Docket Item # 10
BAR CASE # 2009-0034

BAR Meeting
April 1, 2009

ISSUE: Alterations, window replacement
APPLICANT: Mendelson Properties, Limited Partnership
LOCATION: 906-908 Prince Street
ZONE: RM/Residential

Figure 6. Proposed window cut sheet.

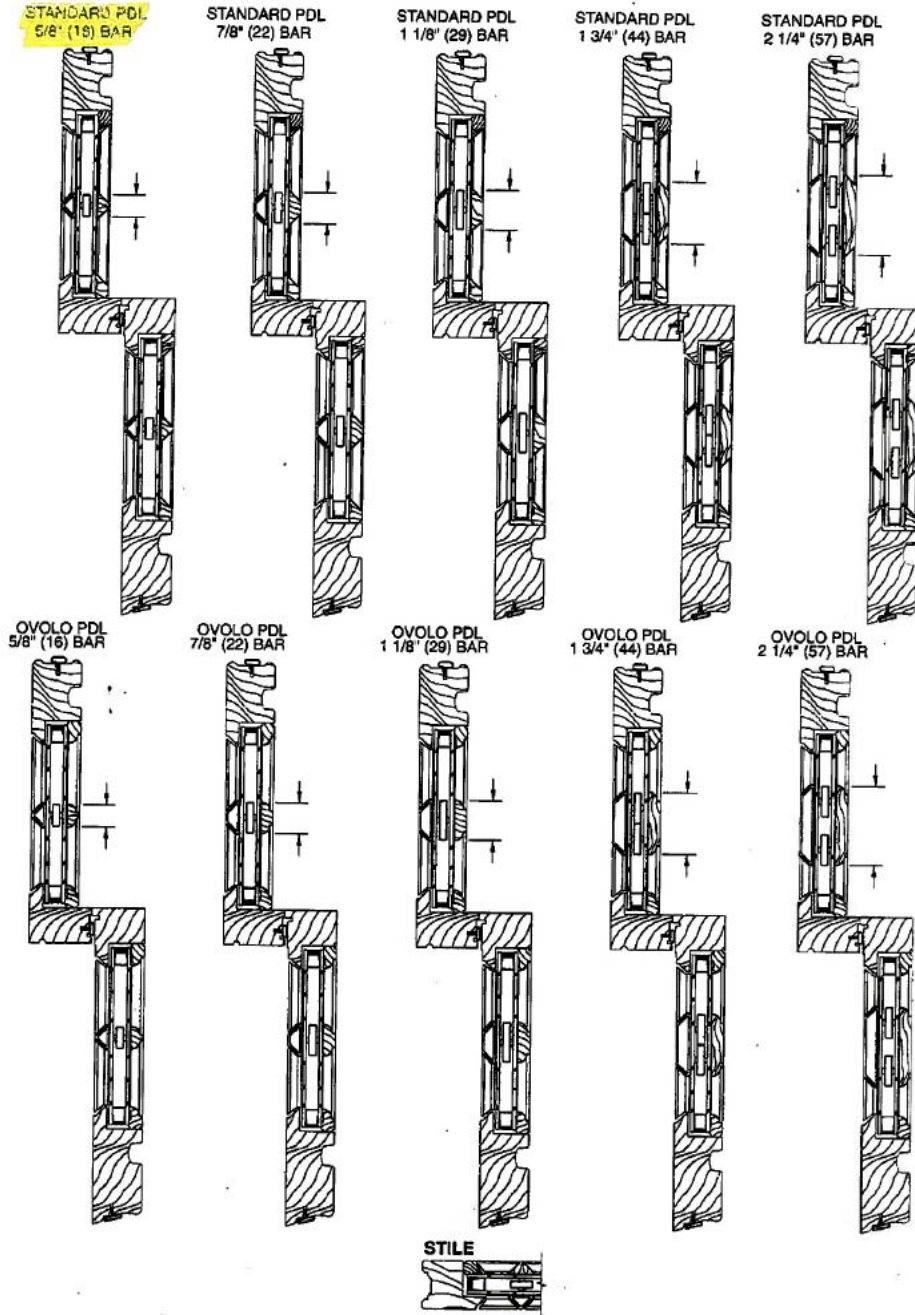
While Staff does not support the wholesale replacement proposed, Staff is also unresponsive of the proposed type of replacement window in this application, in that it is a simulated-divided light, double-glazed window with aluminum exterior muntins, which is not an in-kind replacement for the existing single-glazed, true-divided light all window windows. Staff would recommend that any replacement window be single-glazed and true-divided light wood windows.
